## 3 Ram Power Trim Motor Water Leak

### Models Affected

Models Covered	Serial Number
Mercury/Mariner 135–200 OptiMax	1B804695–1B807280

45688

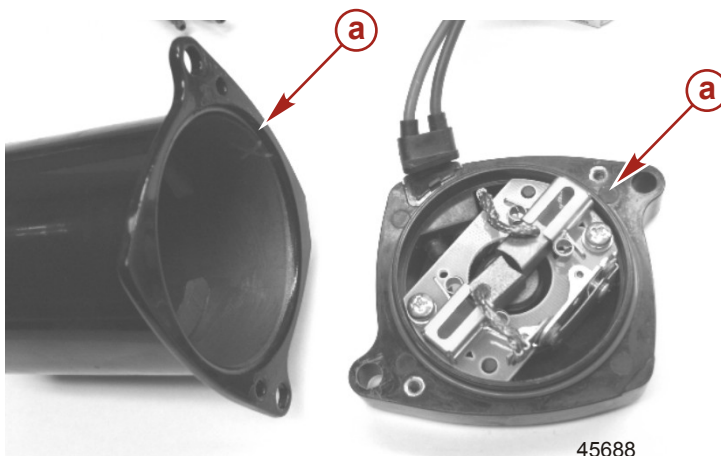
Mercury Marine has determined the seal on some power trim motors may allow water to enter the power trim system which can damage the motor and other internal components of the power trim system. Mercury Marine has identified the cause of this condition and has made appropriate changes to new power trim systems produced.

**a** - Seal located on motor base has a potential to leak due to an incorrect radius on the motor housing flange

45689

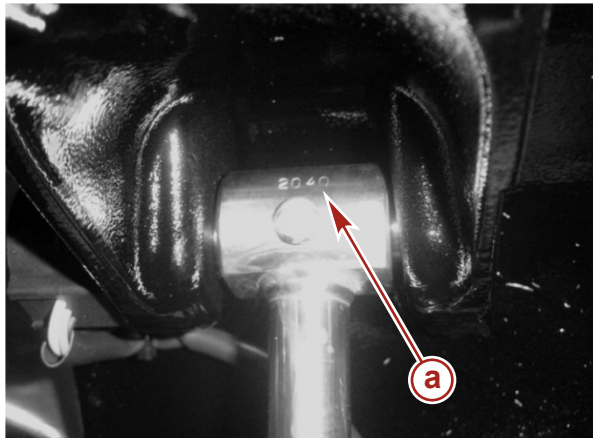
Trim the engine completely up and engage the tilt lock lever. Look for the date code on the trim system located on the top of the ram eyelet just above the retaining pin.

**a** - The date code of 2040 is shown

48399

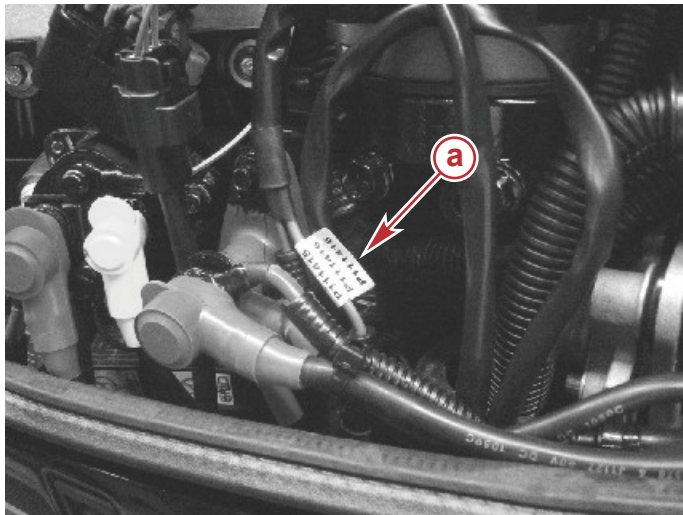
The trim motor date code is located at the end of the motor leads under the cowl in the general area of the hot stud. Suspect power trim systems are within date codes 1370 –1730.

**a** - Date code location

If the power trim is in the date code range, inspect the power trim motor assembly date code. The trim motor date code must be in the ranges of **P101117 through P101613** for trim motor replacement.
